Appendix C- H

16/00424/AOP

**Land Between Wendover Road And Aston Clinton Road Weston
Turville Buckinghamshire**

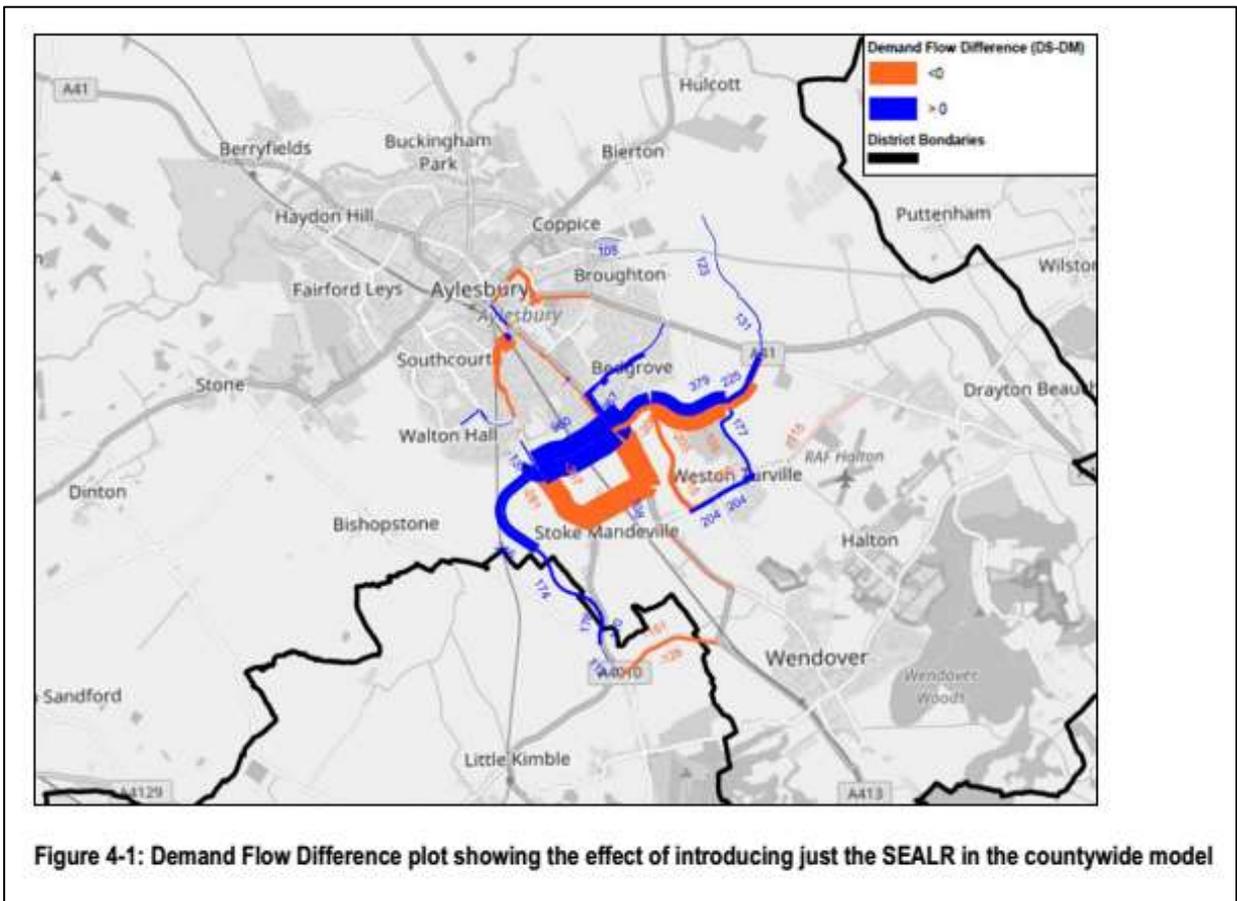
12. This review was undertaken at a high level. It gives an overview of:
 - the way in which the model has been developed;
 - in particular, the methods used to build the trip matrices which differs significantly from the previous model;
 - the standards of calibration and validation achieved; and

- the applicability of the new model in testing the impacts of the Hampden Fields development, the proposed traffic mitigation measures and associated development proposals and road schemes.

13. No direction communication has taken place between TPP and AVDC, BCC or Jacobs at this stage. Reliance is placed on the report(s) provided.

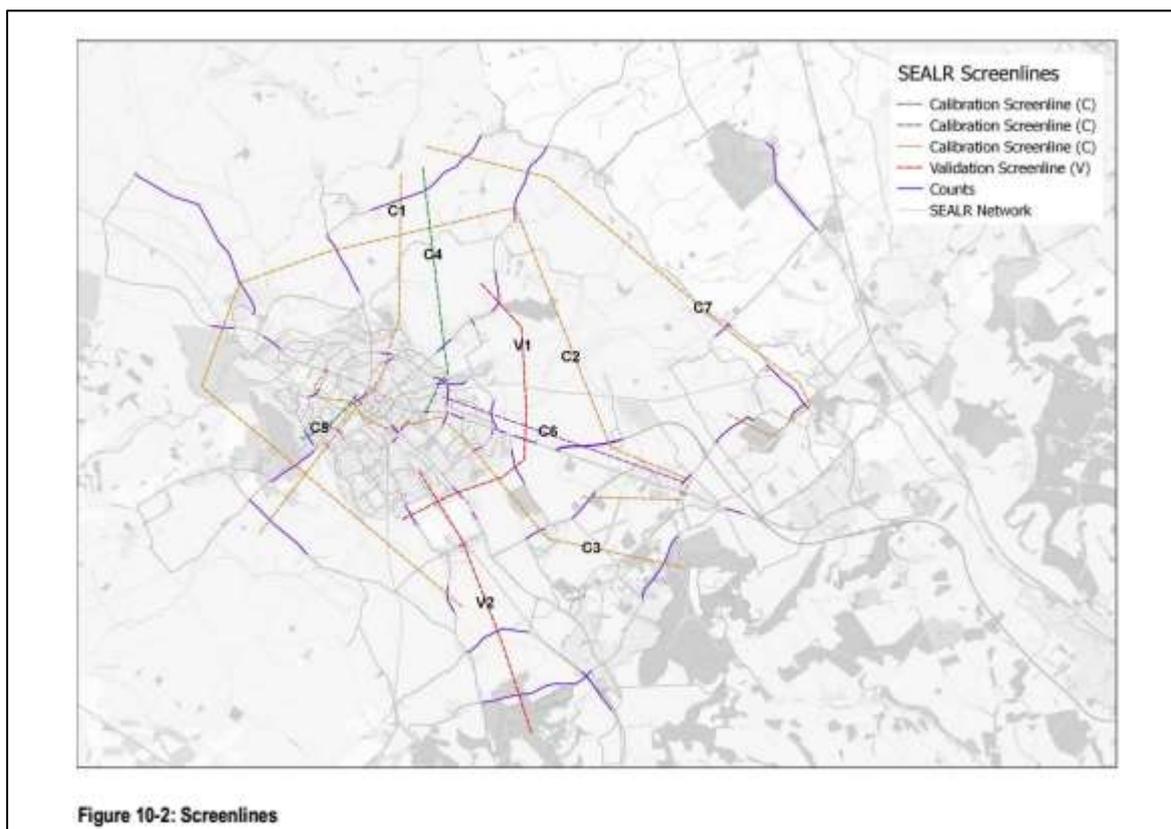
28. Hence, matrix estimation is part of the matrix calibration process, but independent traffic counts should be used for validation.
29. The matrix building process appears to have broadly followed WebTAG guidelines. It is noted that the MPD data is changed considerably during the process and it might be

instructive to see the level of change at various stages in the process. Only the changes due to matrix estimation are presented.

30. TPP note that, at the end of the calibration process, no comparison has been made between the MPD-based matrices and the roadside interview surveys (RIS) carried out on the A418 and A41 in 2014. This would have been a good check on the matrix building process. A select link comparison of the new matrices and the RIS data could be requested from BCC.

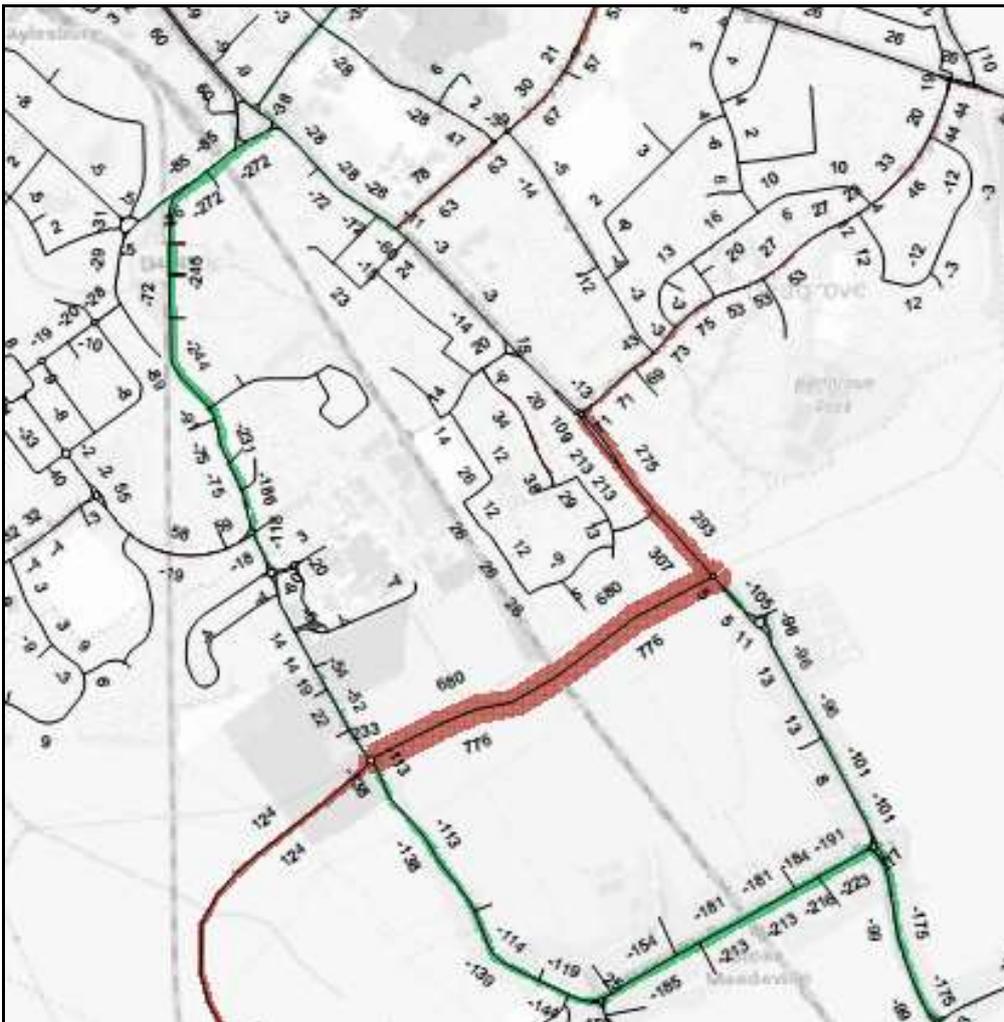
59. In reviewing the 2021 Jacobs Scenario 1 (AECOM 2021 Scenario B) AM peak results, there is an increase in traffic of over 100 vph through the village of Bishopstone, when SEALR is opened. This would be undesirable and, if traffic management measures were taken to prevent such routeing, traffic would alternatively pass through the Walton Street gyratory negating the benefit of SEALR.

60. In reviewing the 2021 Scenario 2 (AECOM 2021 Scenario A) forecasts, which are more of a "Stand-Alone" test of the impact of SEALR, TPP note that the modelling shows significant volumes of traffic diverting onto Camborne Avenue/Bedgrove and Wendover Way. In total about 200 vehicle per hour (vph) will be diverted. This is shown in Appendix D of Appendix F of the Transport Assessment (summarised in the inset below).

61. A traffic increase of this nature is unlikely to be acceptable to local residents. Mitigation measures would be required. Measures to prevent traffic increases on these roads, will tend to push traffic back towards the Walton Street gyratory. This would negate the supposed benefits of SEALR.
